WAMBO COAL PTY LTD

NORTH WAMBO UNDERGROUND MINE LONGWALL 10A MODIFICATION

RESPONSE TO SUBMISSIONS

December 2014

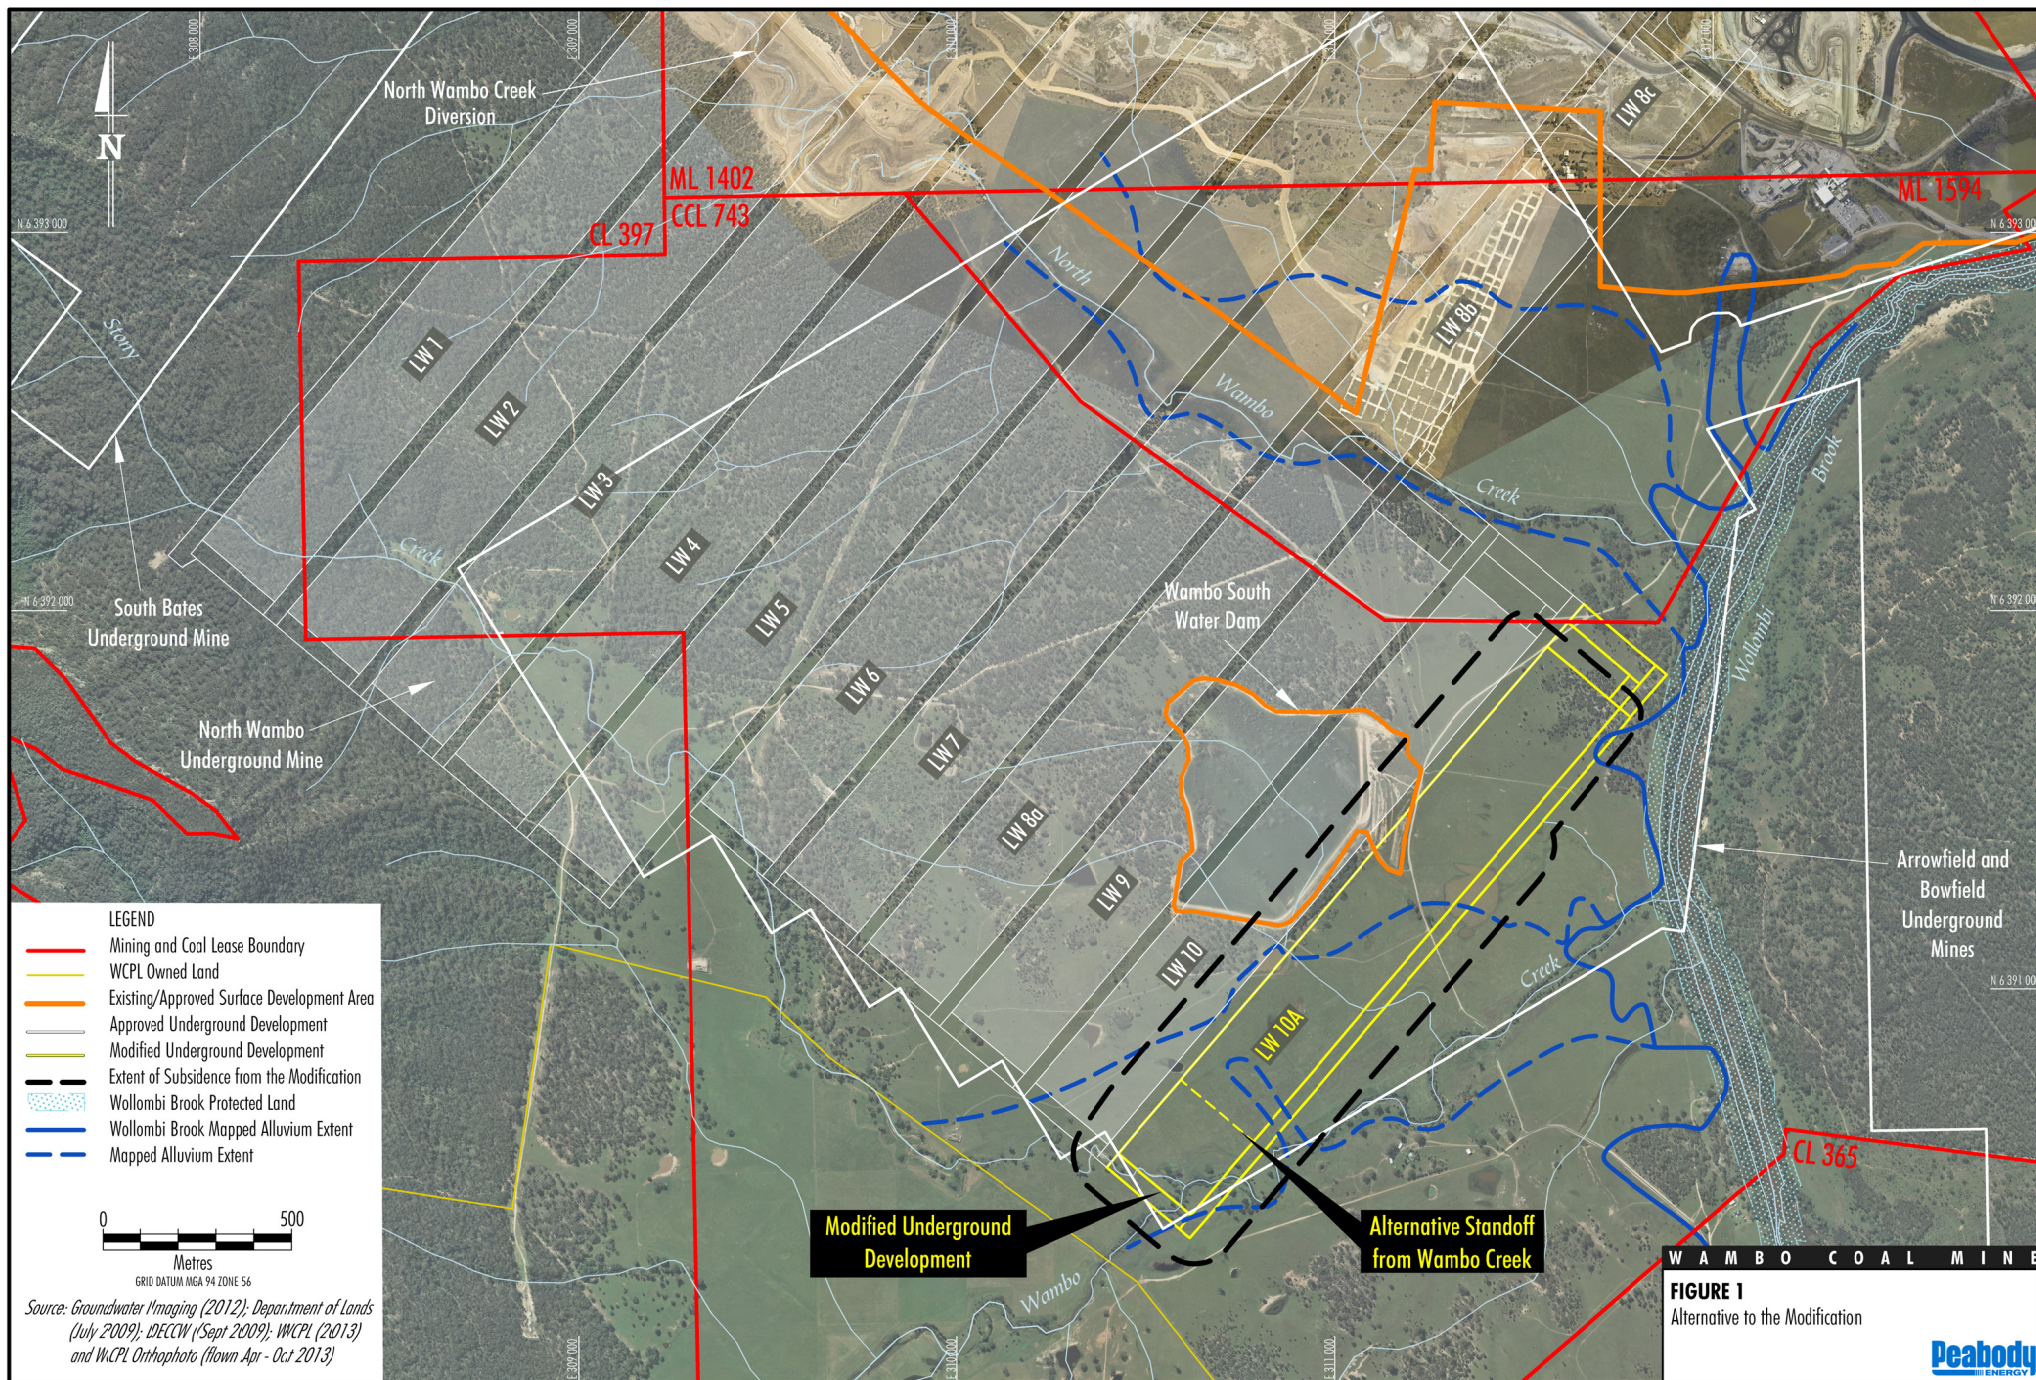
As an outcome of the submissions, WCPL has considered the costs and benefits associated with implementing a standoff of the proposed Longwall 10A from the Wambo Creek channel.

WCPL has assessed the implications of reducing the length of proposed Longwall 10A by 245 metres (m) to avoid directly undermining the Wambo Creek and Stony Creek channels by the proposed Longwall 10A (i.e. reducing the length from 1,745 m to 1,500 m) (Figure 1). These implications would include:

- Sterilisation of 262,000 tonnes of ROM coal, equivalent to 14% of the total ROM coal that could be recovered from the proposed Longwall 10A.
- Lost revenue to WCPL in the order of \$13.5 million at 2014 pricing.
- Lost royalties to the state of NSW of approximately \$0.9 million.

- Potential for operational discontinuity in the order of 3 weeks.
- Reduction in additional total subsidence on the relevant section of Wambo Creek from 2,400 mm to 1,600 mm (i.e. in addition to the previous subsidence that has already occurred as a result of mining in the Whybrow Seam). This would result in a maximum gradient along this section of Wambo Creek prior to remediation of 2.2% compared to 3.8% with the extraction of the proposed Longwall 10A.

- Reduction in additional total subsidence on the relevant section of Stony Creek from 1,500 mm to 1,000 mm (i.e. in addition to the previous subsidence that has already occurred as a result of mining in the Whybrow Seam). This would result in a maximum gradient along this section of Wambo Creek prior to remediation of 1.7% compared to 2.2% with the extraction of the proposed Longwall 10A.

- Reduced subsidence movement on four artefact scatters (noting these scatters are approved to be impacted by the future mining in the Arrowfield and Bowfield Seams).

WCPL does not consider the above alternative is justified given:
